CITY OF ALBUQUERQUE

RE: **Lot 17 Block 5 Volcano Cliffs Unit 2 SAD 227**
7928 Victoria Dr. NW
Grading and Drainage Plan
Engineers Stamp Date: 8/10/2020 (E10D081)
Pad Certification Date: 5/16/2022

DRAINAGE AND TRANSPORTATION INFORMATION SHEET (REV 6/2018)

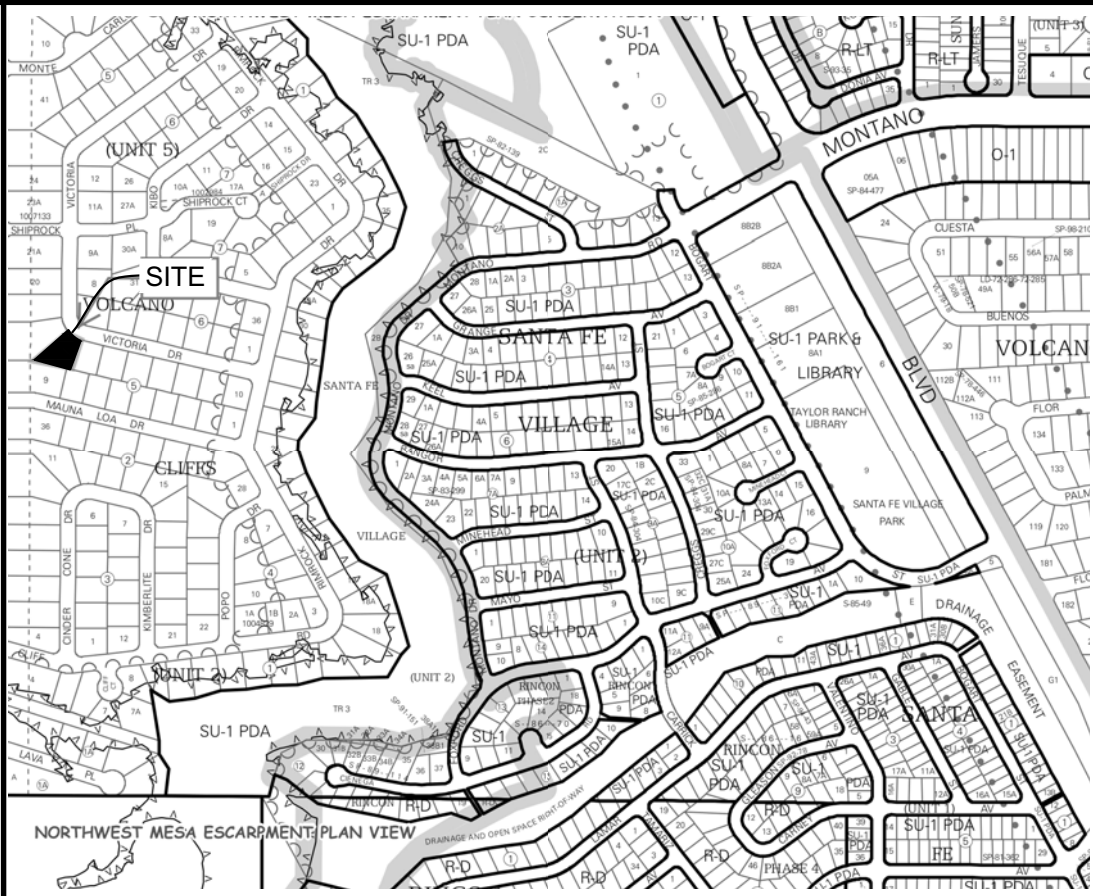
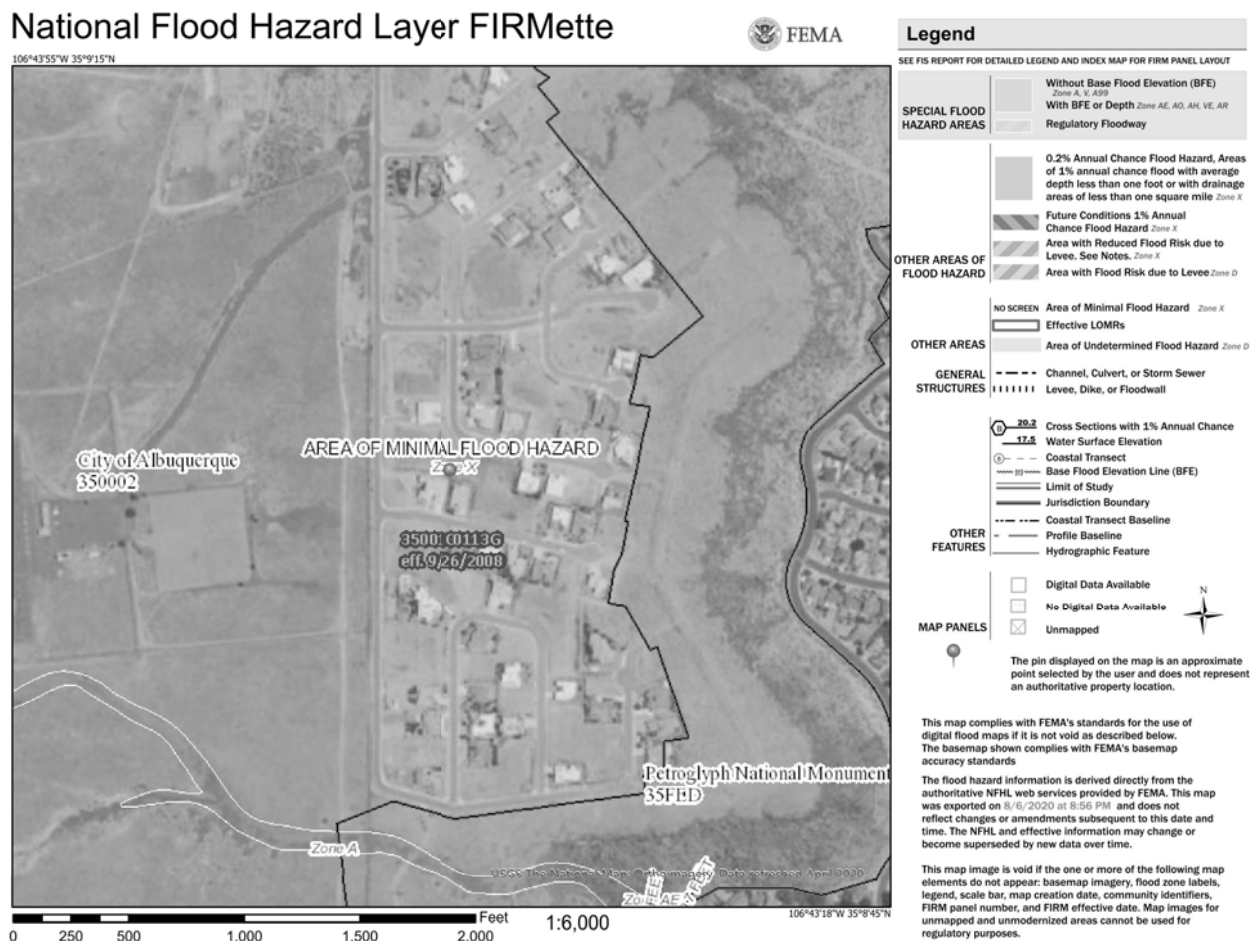
Based upon the information provided in your submittal received 10/14/2022, this plan is approved for building permit.

Reiterate to the Owner/Contractor that a separate permit for a garden/retaining wall must be obtained, with the approved G&D plan and Pad Certification. Inform the owner & Contractor that dirt is not allowed in the public right of way to climb the curb. Crusher fines or lumber is allowed. If dirt is used this will delay going forward with the construction of the home.

Prior to Certificate of Occupancy release, Engineer Certification per the DPM checklist of this plan will be required.
